TSI 01/13

Ford | Mazda | Volvo

028.230

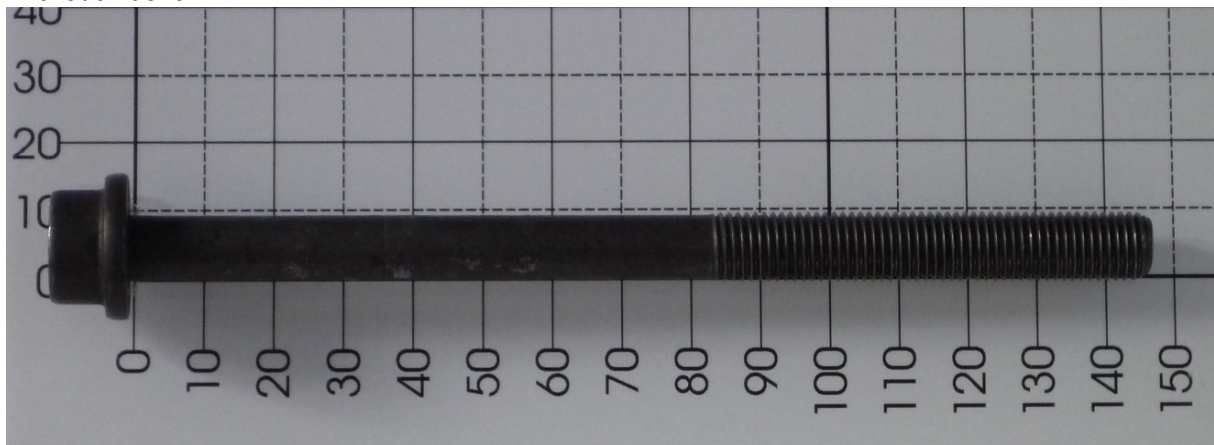
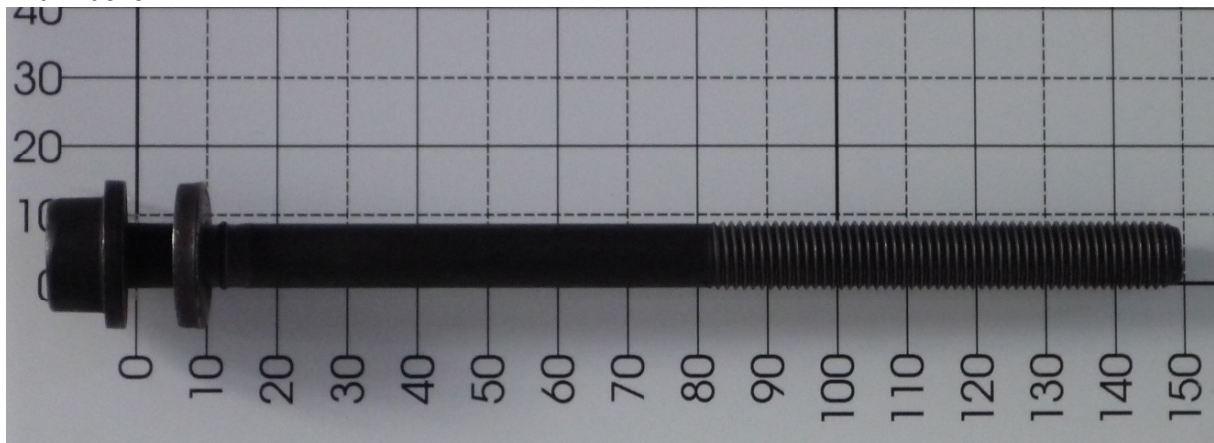
New:

M10 x 1,25 x **145,5** Torx T55

Without washer

Replaced:

M10 x 1,25 x **149,5** Torx T55

With washer

Note: Cylinder-head bolts are replaceable.
